PERMIT APPROVAL AMENDMENT MODIFICATION APPLICATION

Project Name: THE RIDGE AT MONROE

INCREASE IN DETACHED SINGLE FAMILY UNITS FROM 19 TO 25.

MINOR MODIFICATION OF PERMIT:

TITLE
**OVERALL
 SITE
 DEVELOPMENT
 PLAN**

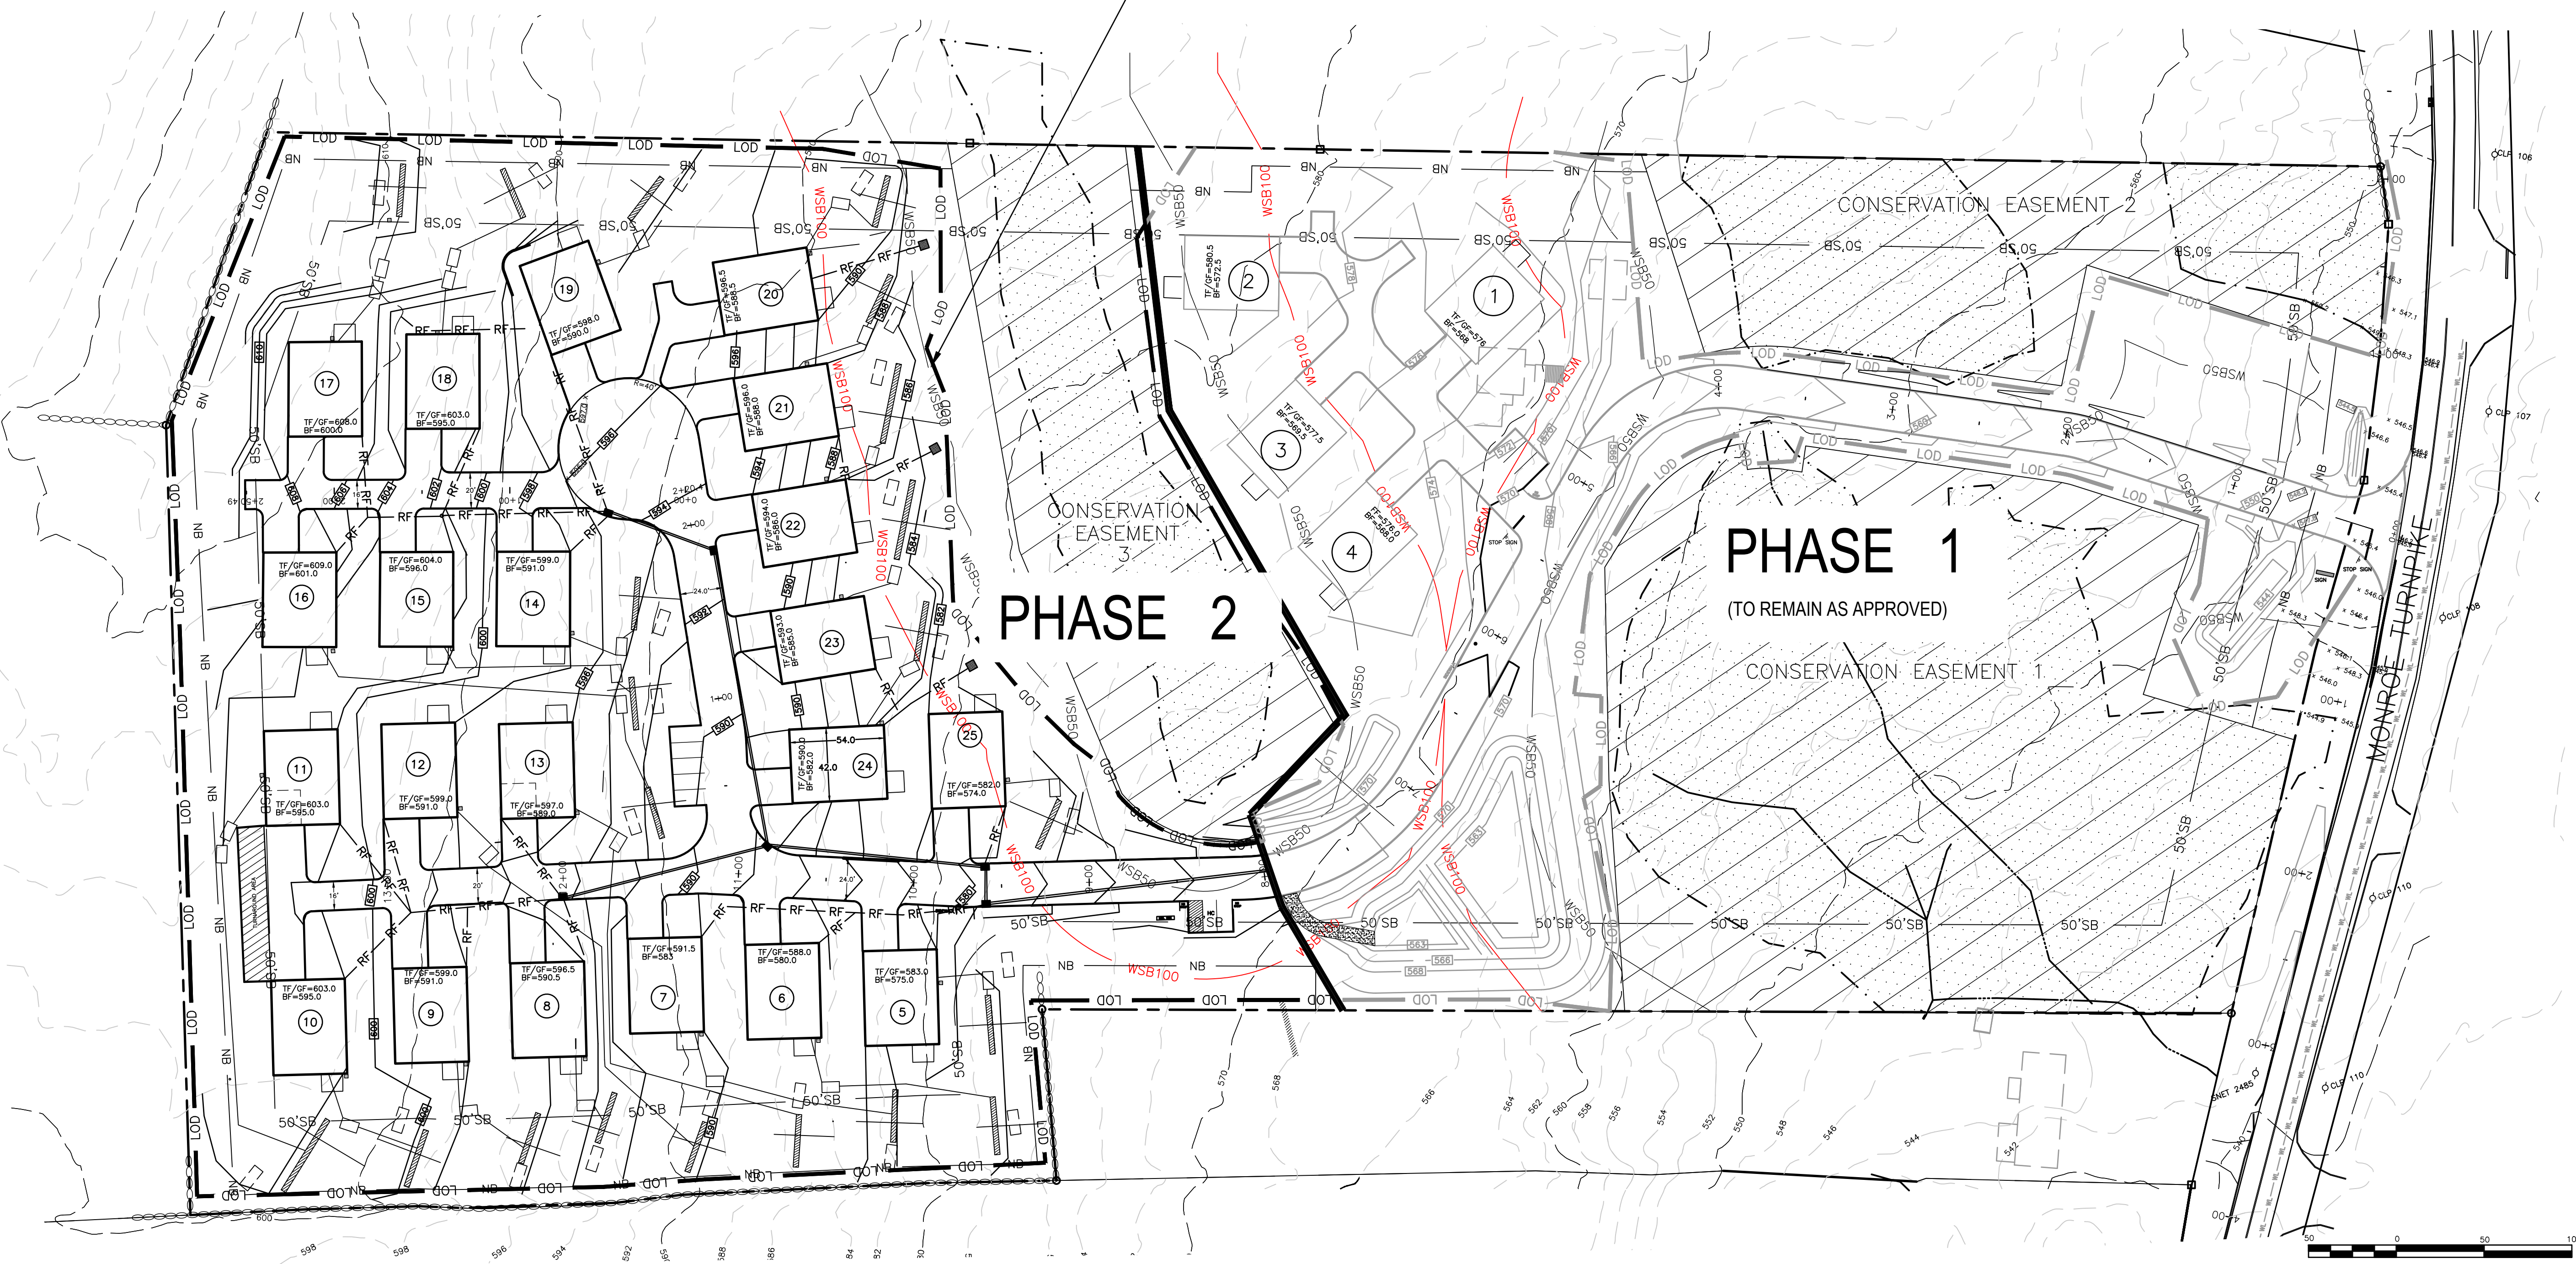
The entrance and phase 1 will remain as approved, with the exception of drainage modifications related to CT DOT. Phase 2 includes additional units and changes to vehicle access.

TITLE
EROSION CONTROL PLAN
 SHEET NUMBER

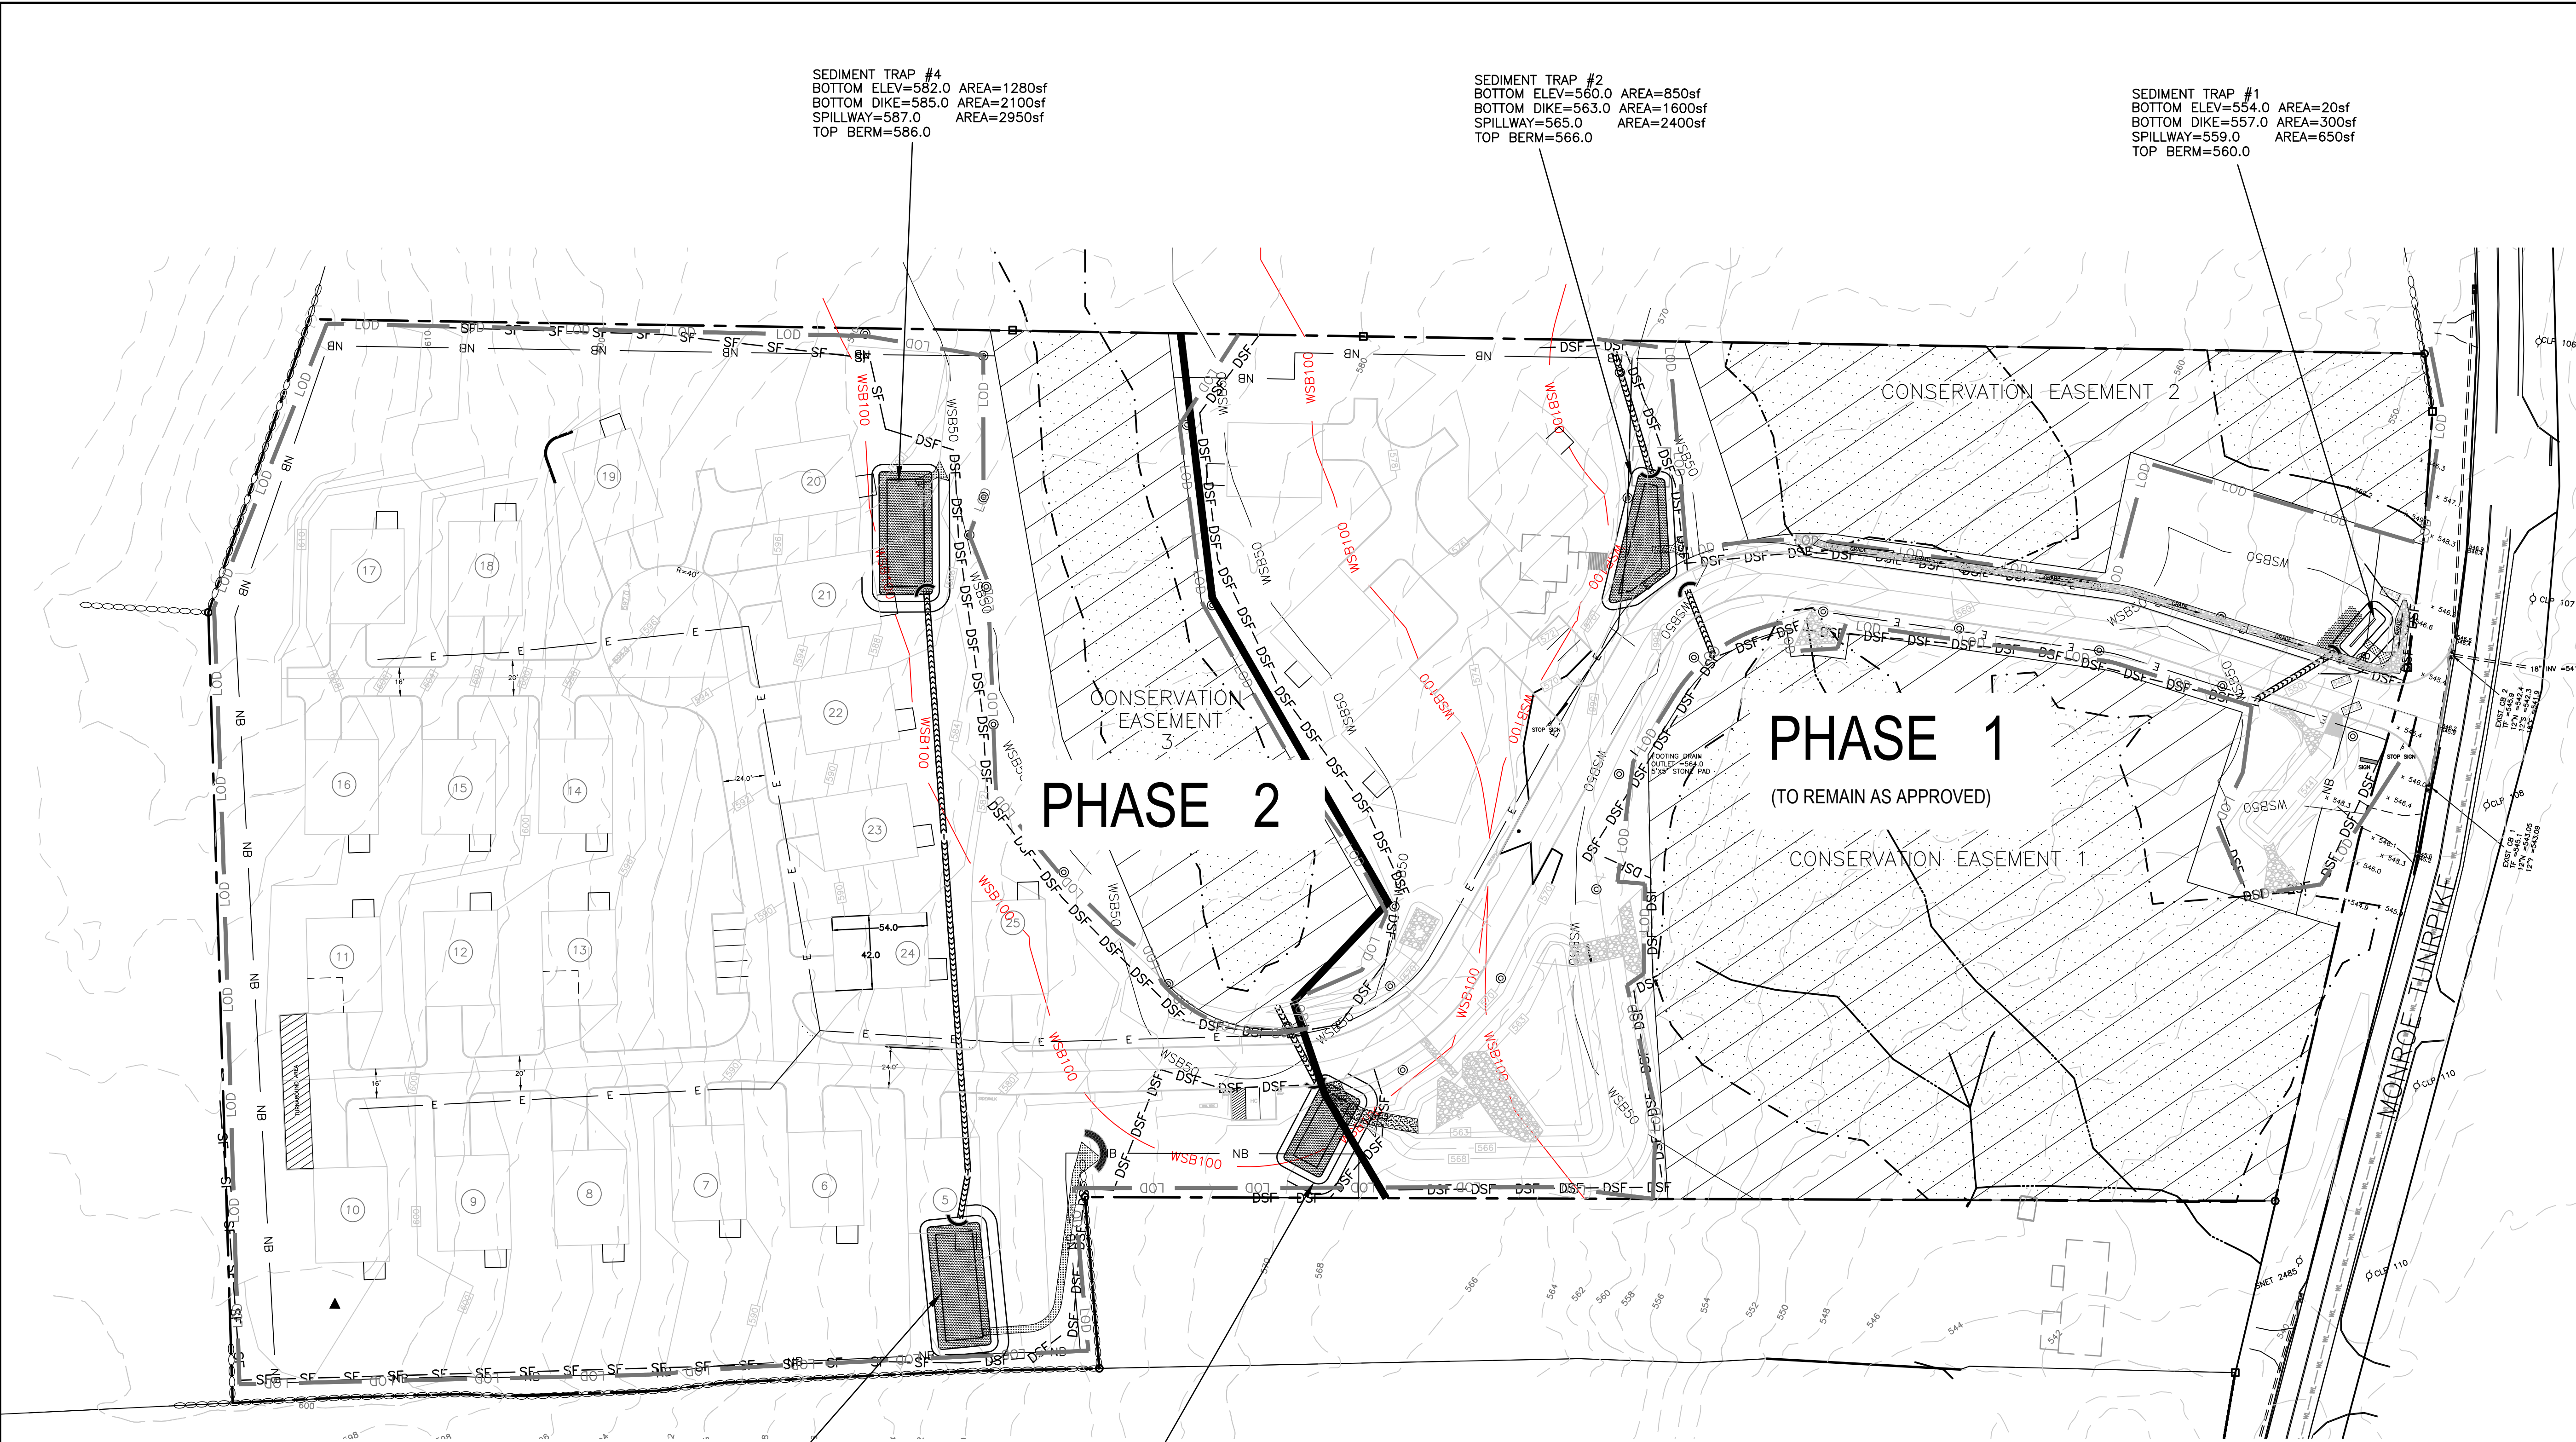
PHASE 2

PHASE 1
 (TO REMAIN AS APPROVED)
